**Subject: Carrier Corporation, Thompson Road Facility, Syracuse, New  
York Corrective Action Order — Index CO 7-20051118-4  
Site Registry No.: 734043  
Annual Site-Wide Groundwater Monitoring Plan - Revised**

# ANNUAL SITE-WIDE GROUNDWATER MONITORING PLAN

United Technologies Corporation/Carrier Site  
Thompson Road, Syracuse, NY

J:\Projects\60310231\_UTCAOCGRIM\SCGIS\Maps\Site-Wide\Monitoring PLAN\03 PROPOSED GW SAMPLING NETWORK.mxd 10/24/2017

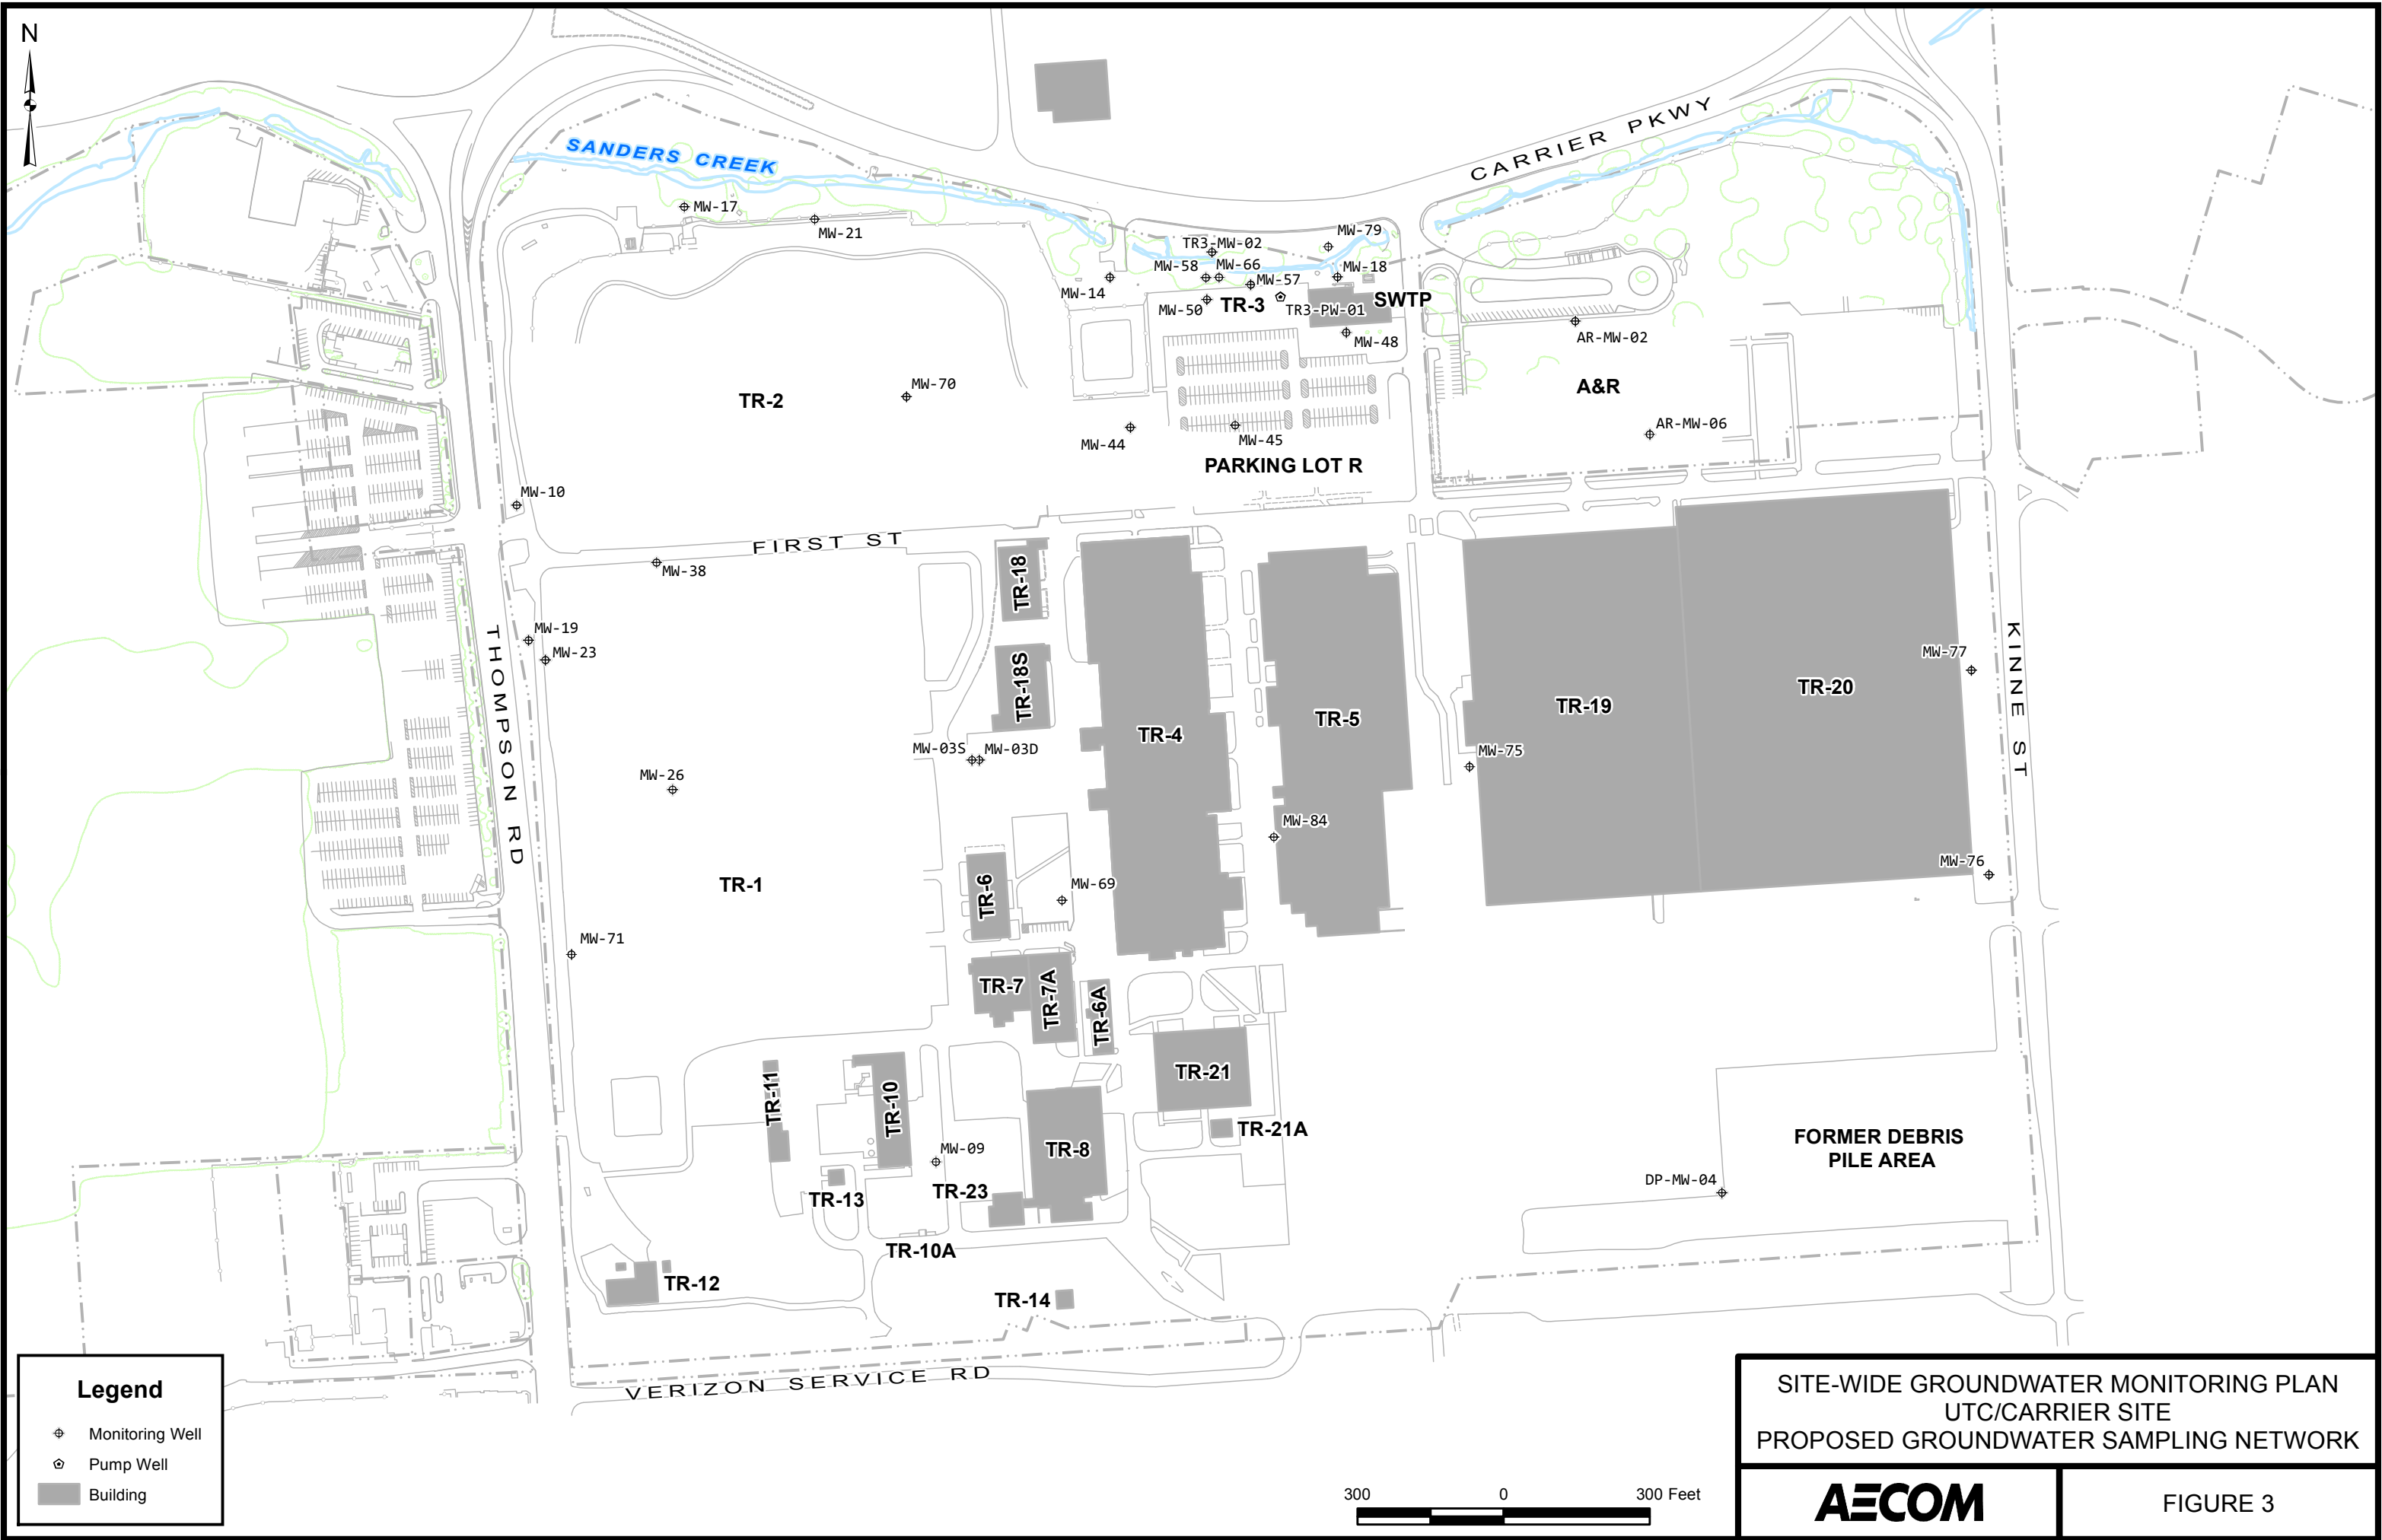
In section 5 of the Narrative, Monitoring Wells 23, 26, 28, 38, and 44 are listed to be sampled for PCBs. Monitoring Wells 26 and 28 are not listed in Table 1, Appendix B, or Figure 3 to be sampled and MW-44 is listed only to be sampled for VOCs in Table 1. Please clarify what will and won't be sampled for VOCs and PCBs.

Appendix B shows MW-22D as being sampled but the narrative, Table 1, and Figure 3 show the well not being sampled.

The document has been revised to clarify what wells will and will not be sampled for PCBs and VOCs.

MW-22D will not be sampled. The document has been revised to reflect this.
